November 25, 2012

AN ENGINEER REVIEWS THE “DURLACHER MODEL SCHOOL ANALYSIS”

Chairman Stan Durlacher of the CCRHS Building Committee has publicly presented, handed out, and published an “analysis”, supposedly comparing costs for his planned building design with costs that might be achieved with two representative MSBA Model School designs. He concluded that these Model Schools would cost us MORE, by \$14,479,482 or \$12,593,770.

Figure 1

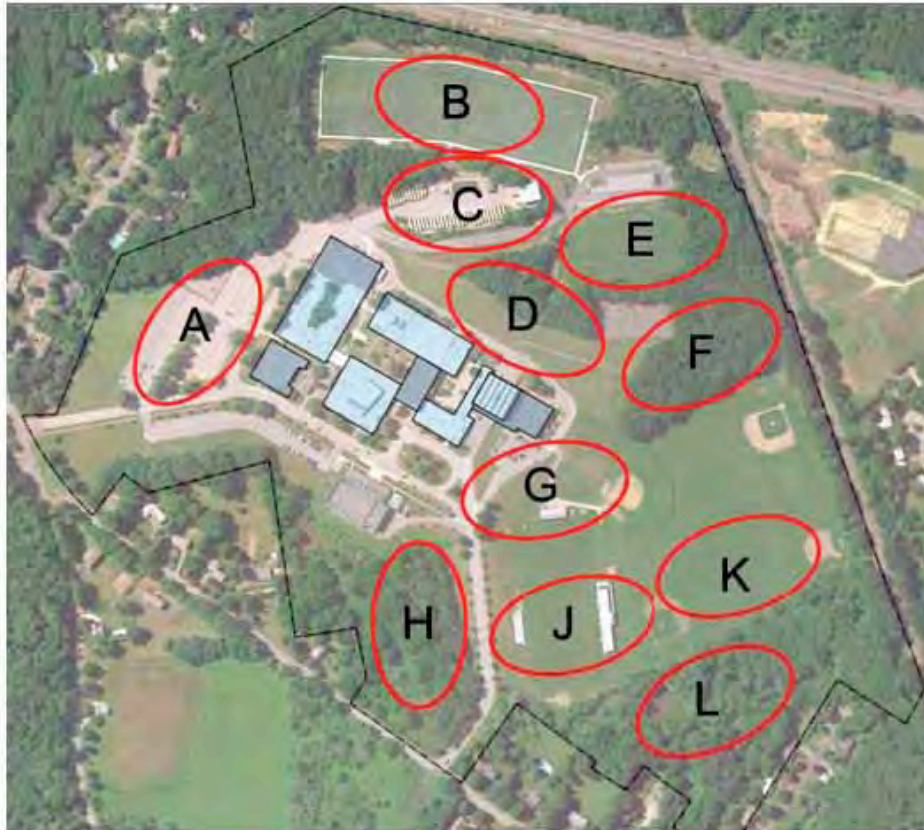
So far, putting the Hudson design on the athletic fields appears to be the least expensive option, but it is not the best we can do. We have also been looking at the Whitman Hanson design, and the others derived from it. For a better proposal to put a model school on the CCRHS property I've copied an aerial picture of the Norwood High School, completed last year and a near duplicate of the Whitman Hanson School, and have adjusted its size to match the more recent Natick High School. I have combined an illustration to show how the Natick Model School can easily fit on the "Site 12", or "G", just northwest of our present school. (**Figure 1.**)

Because neither location considered by Mr. Durlacher appears to be a good placement for a model school, I have chosen to put my copy of the Natick school on "Site 12". Site 12 was considered the *best* option by the Building Committee meeting of May 25, 2011, -- and more recently by the two other school design firms -- but for some reason was never discussed again in an open meeting. In the June 13, 2011, "Update" issued by OMR for public presentations in Concord and in Carlisle, on page 13, the Site 12 is marked as "G". (Shown here in **Figure 2**, with North at the bottom.) The less suitable location strangely picked by the Building Committee for the OMR custom design work is marked "D", but was formerly known in the Feasibility Study as location "14C".

Because Site 12 is on a hillside, dirt may be cut from the high side and filled into the low side to level it as much as may be desired. If even more fill is needed, it is readily available from the high hill just south of the present school, exactly where OMR already intends to remove it to make room for their planned construction. Any addition surcharge dirt needed for compaction of the fill can easily be borrowed from the baseball field area just west of Site 12, then returned when it has served its purpose. The amount of site leveling work needed can be reduced further by positioning the new Model School slightly to the north of the place I illustrated, there covering more of the adjacent lacrosse field and getting farther from the slope. The school foundation could also be lowered a couple of feet.

With a more realistic but still generous pricing for extra Geotechnical costs, given that the maximum slope correction of 16' at Site 12 is *less than half* the 37' slope correction needed by Mr. Durlacher at his Hill site, and given that the soil preloading time will be about *2 months* rather than his arbitrarily assumed 9 months, those added Geotechnical costs will be less than \$3,000,000 for Site 12. There are no extra "hard costs" nor "soft costs" to be added, as the amounts Mr. Durlacher listed are already included in the cost of the Model School, or were not included in the OMR construction cost for this comparison. This maximum of \$3,000,000 replaces the much larger amounts (adding to \$22,598,750) from Mr. Durlacher's pages 18, 19, and 20. The cost for putting the Whitman-Hanson school or the related Natick school design on Site 12 then would be \$67,984,938, to be compared with the \$88,494,844 we voted for the present OMR design. This potential saving of \$20,509,906 is far more than the \$3,489,000 in the "sunk cost" (the value of the Existing Design Work lost), plus even a generous extra \$3,000,000 for special preparation of Site 12. Of course, not all of that design work is really lost because much of it was a study of the site options, one of which can be used. Only the OMR building design work to date will be wasted.
